**SUBDIVISION REVIEW SHEET
(VARIANCE ONLY)**

CASE NO.: C8-2017-0124

SUBDIVISION NAME: Lightfield Preliminary Plan

SUBJECT: Variance Request Lightfield Subdivision
Case Number – C8-2017-0124

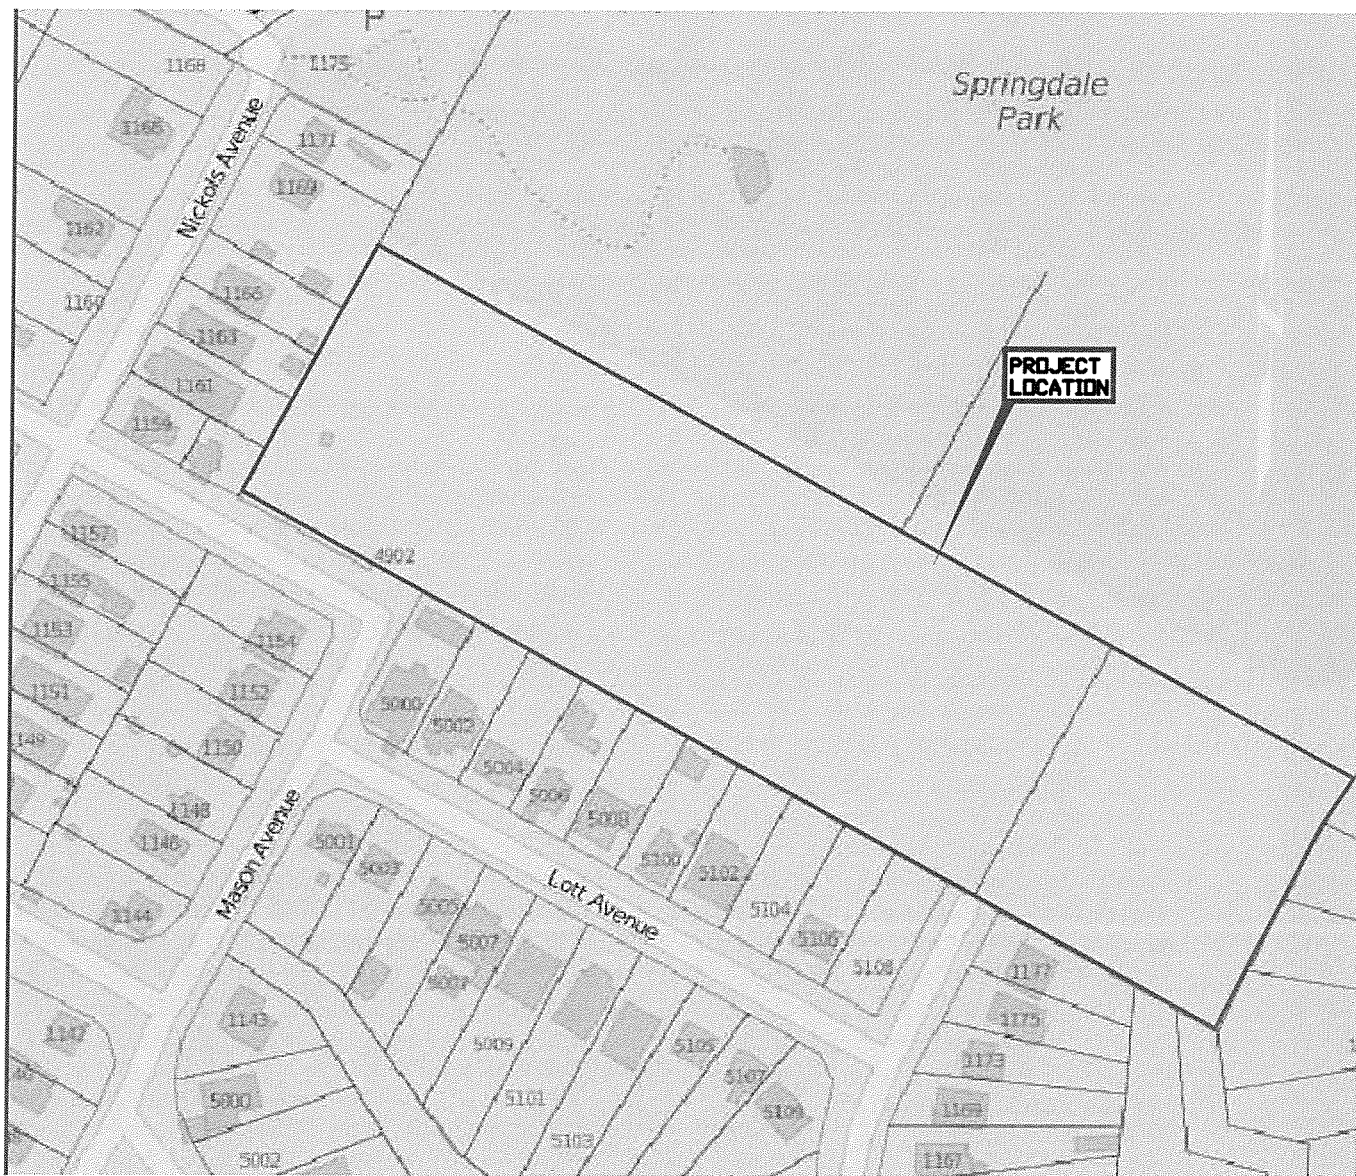
VARIANCES: The applicant is requesting a variance from LDC Section 25-4-151 which requires streets in a new subdivision to be in line with existing streets on adjoining property. The variance is to not extend Lott Ave. into the proposed subdivisions. RECOMMENDED. (See attached memorandum from transportation review).

DEPARTMENT COMMENTS: The proposed plan is composed of 25 lots on 5 acres. At this time, the request is for approval of the above referenced variance only. Once all remaining review comments are cleared by the applicant, the plan will be brought back to the Commission for consideration.

STAFF RECOMMENDATION: The staff recommends approval of the above referenced variance request.
